## 463-2022 ADDENDUM 3

### NEWPCC PRIMARY CLARIFICATION UPGRADE PROJECT

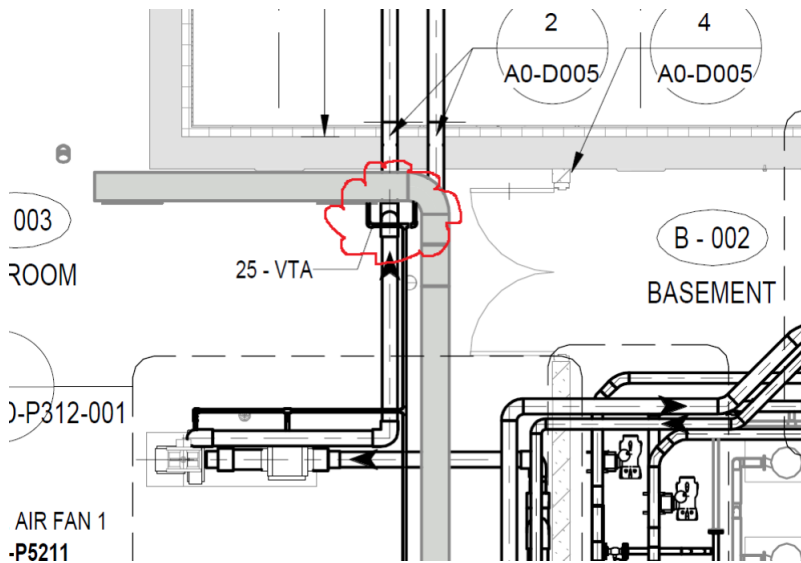
A81: Refer to Addendum 3-Appendix\_A 40 05 13.01 Detailed Piping Specification\_R1
